PLAN-012947

Proposal: First floor rear extension to form level access shower room.

Site: 10 Sea Front, Hayling Island, PO11 9HL.

APP/15/01421

EASTOKE

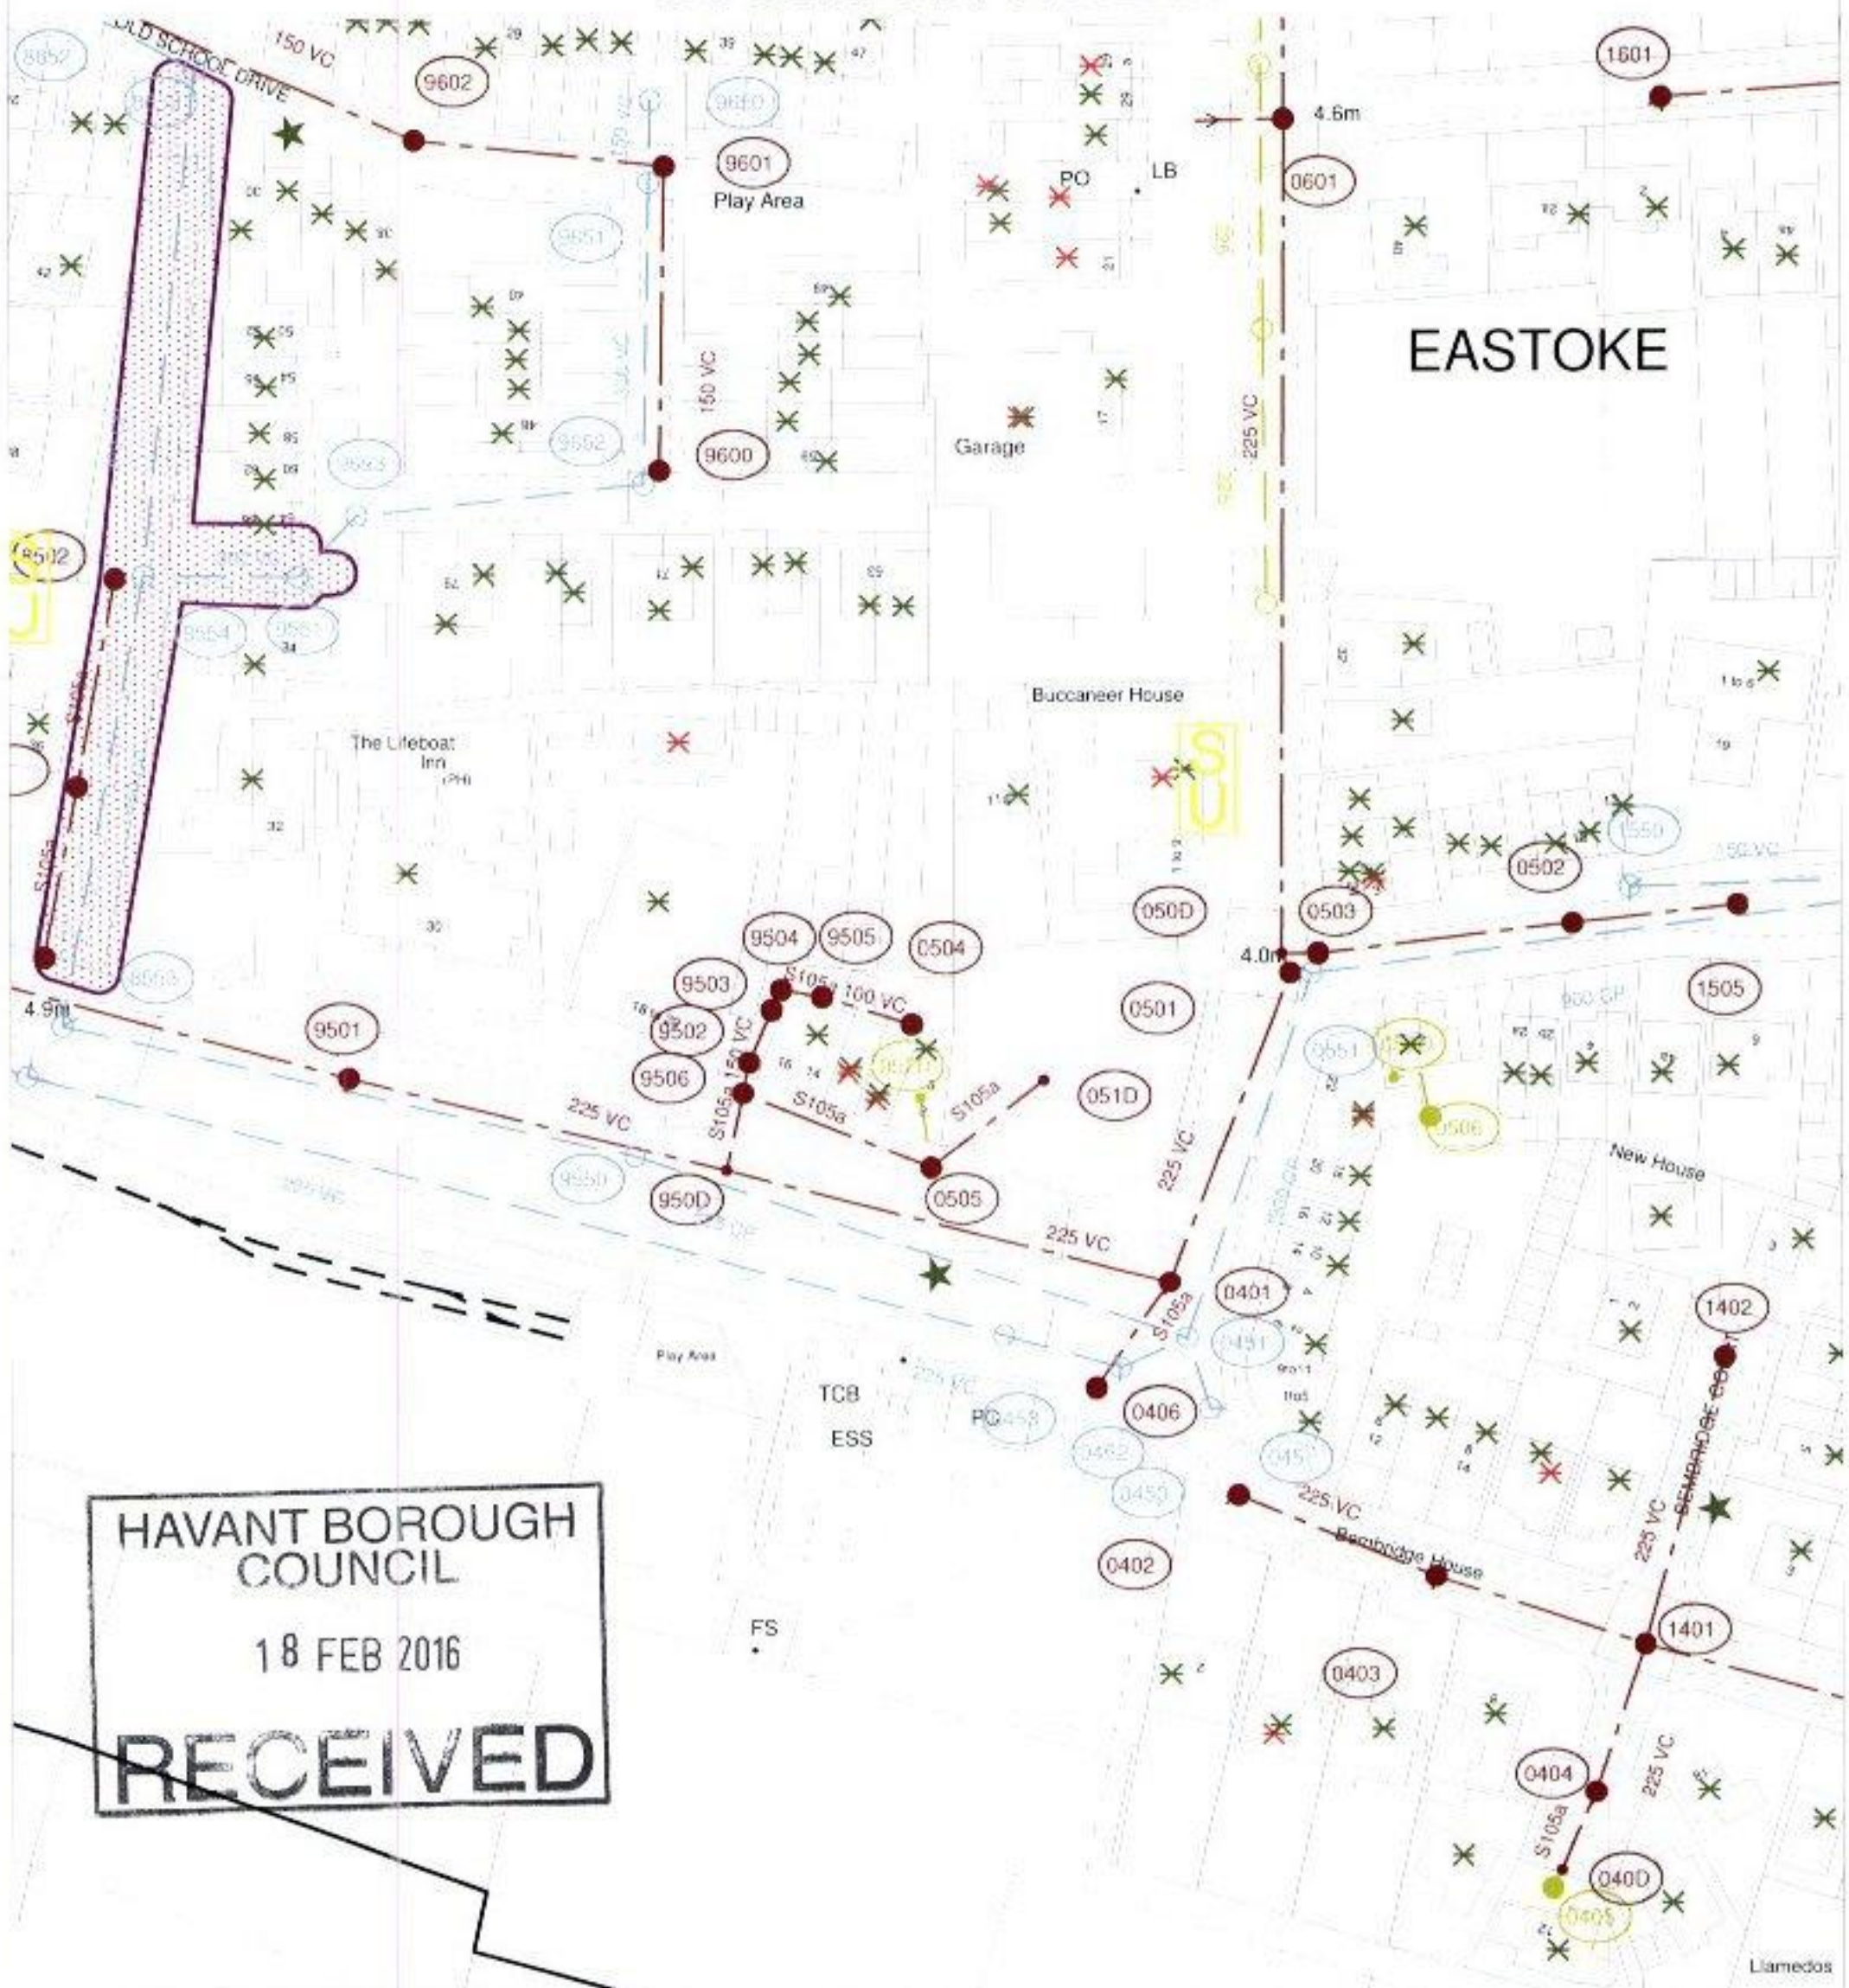
Please find attached a plan of the sewer records showing the approximate position of a public sewer within the site. The exact position of the public sewers must be determined on site by the applicant before the layout of the proposed development is finalised.

Any changes to the building foundations will require Southern Water approval. The design for additional loads should take into account of that construction that will be affecting the public apparatus. In order to protected public apparatus foundations should be taken down 150mm below the invert level of the sewer.
